Airworthiness Concern Sheet

<p>Reply to: Name: Eduardo Orozco Title: Aviation Safety Engineer Office: AIR-772 Street Address: 3960 Paramount Blvd, Suite 100 City, State, ZIP: Lakewood, CA 90712 Telephone: 562-627-5264 Electronic Mail: Eduardo.Orozco-Duran@faa.gov</p>	<p>Make: Robinson Helicopter Company Model / Series: R44/R44 II/R66 Serial Numbers: All Reason for Airworthiness Concern: Separated Push-Pull Tube</p>
--	---

Federal Aviation Administration (FAA) Description of Airworthiness Concern

Figure 1. Upper Right and Left Push-Pull Tubes and Rod Ends.

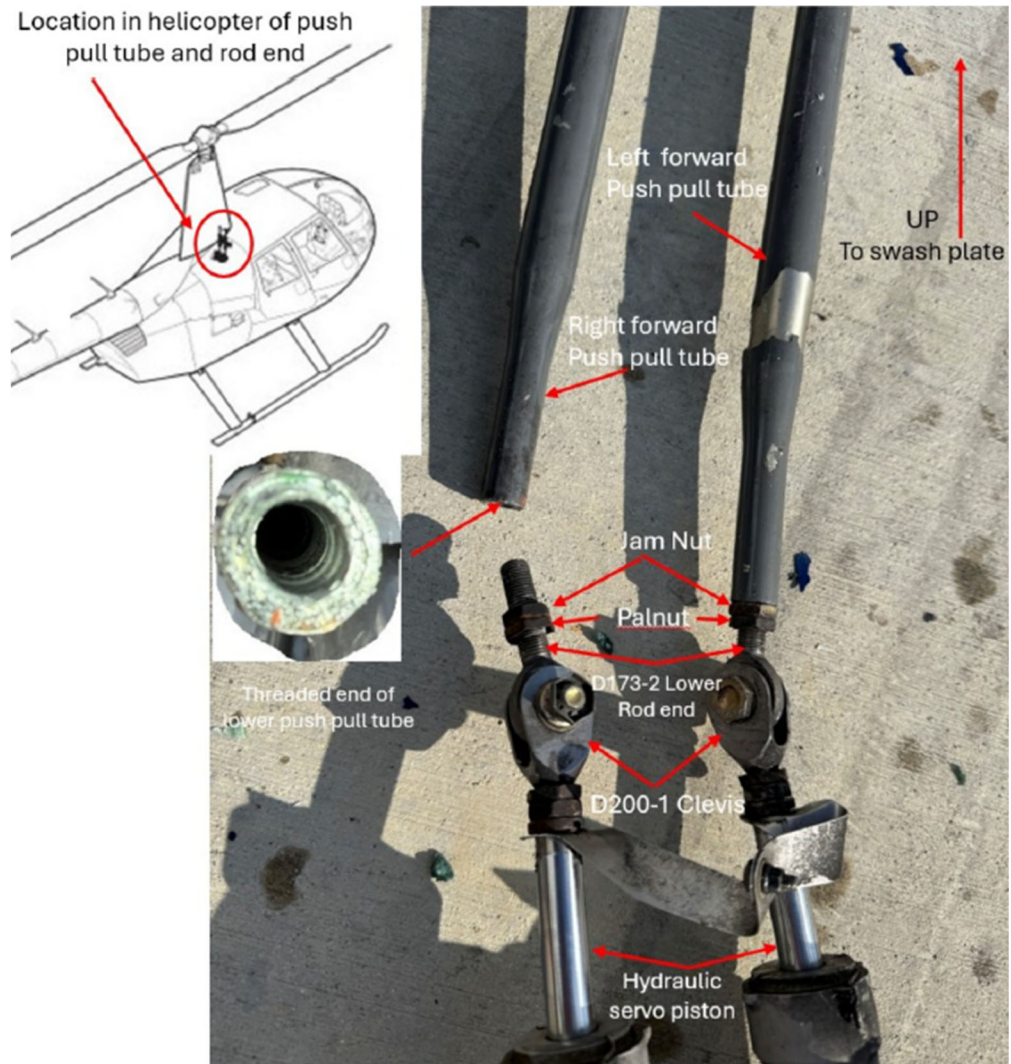
The palnut and jam nut that secure the upper right push-pull tube to the rod end could not be rotated by hand on the rod end threads. The upper right push-pull tube was observed to be elongated at the threaded end (see figure 1). Remnants of torque stripe paint were present on the push-pull tube, palnut, and jam nut. The palnuts and jam nuts on the left and aft lower rod ends and below the hydraulic servo clevis were found to be finger tight. Reference NTSB preliminary report ANC26FA021 for more information.

Figure 2. Hydraulic Servo-to-Swashplate Push-Pull Connection (3 Places).

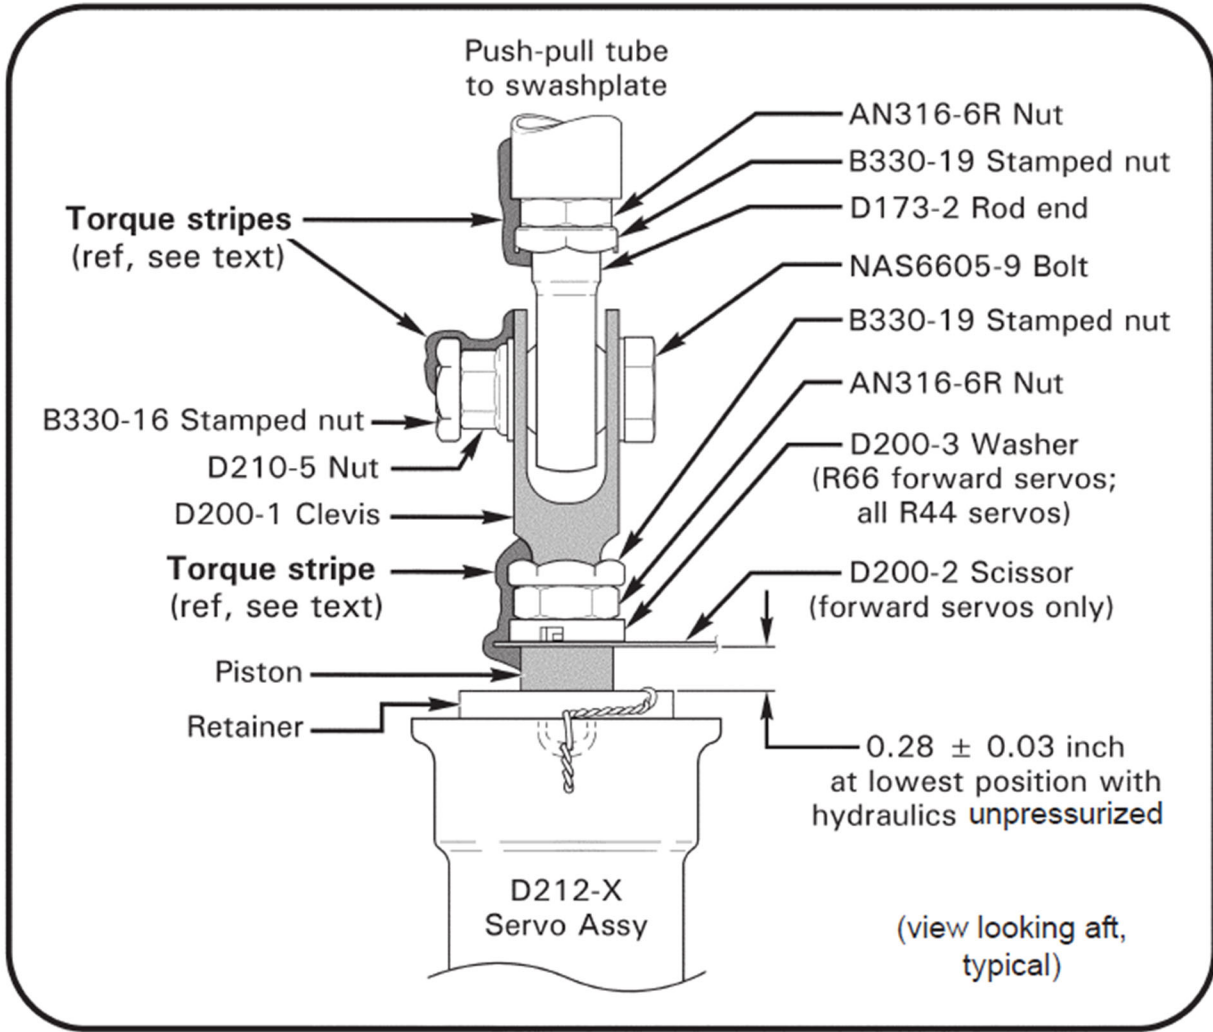
The FAA is interested in receiving information of abnormal damage around the hydraulic servo-to-swashplate push-pull tube connection (see figure 2), including but not limited to:

- loosening hardware
- broken, missing, or inadequate torque striping
- palnut or jam nut damage
- corrosion
- fretting dust or damage to the internal threads of the servo clevis or push-pull tube

We recommend operators perform Robinson R44 Service Bulletin SB-119 and R66 Service Bulletin SB-45 dated May 11, 2026 or later revisions. If completed, please provide the information requested in Step 12 of the bulletin to the FAA.
